1. B.L.M. c/o Powell Butte View Estates Water Dist. (start card number 95165)

REQUEST FOR WRITTEN APPROVAL TO USE CONSTRUCTION METHODS NOT INCLUDED IN OREGON ADMINISTRATIVE RULES 690-200 THROUGH 690-240

Date of request: 11/7/96 (telcon/onsite w/ Larry Carry)

(7) Diagram showing the pertinent features of the proposed well design and construction (attach additional pages if needed):

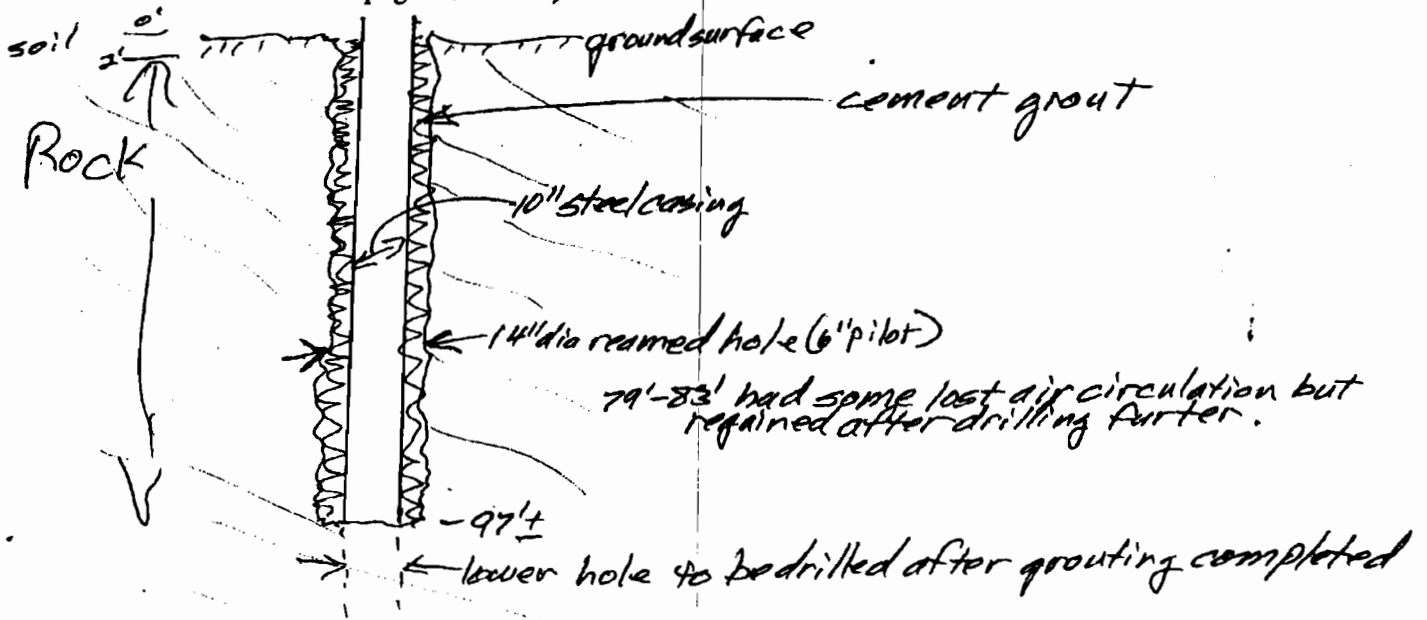
(5) The unusual conditions which necessitate this request: Attempted to get tremie pipe below 20' in annulus but was not successful. Hole (not casing) has deviations from reaming. Would like to seal to 97' by freefall grout below tremie - No water in hole,

(6) The proposed construction methods that the well constructor believes will be adequate for this well (attach additional pages if needed) See (5) above. Encountered rock @ 2' and continues to 97'. Can call grout 'backfill' below 18' but would like to call it 'seal'. Grout will not dilute because no water is in hole.

Approved by: [Signature] Denied by: _____
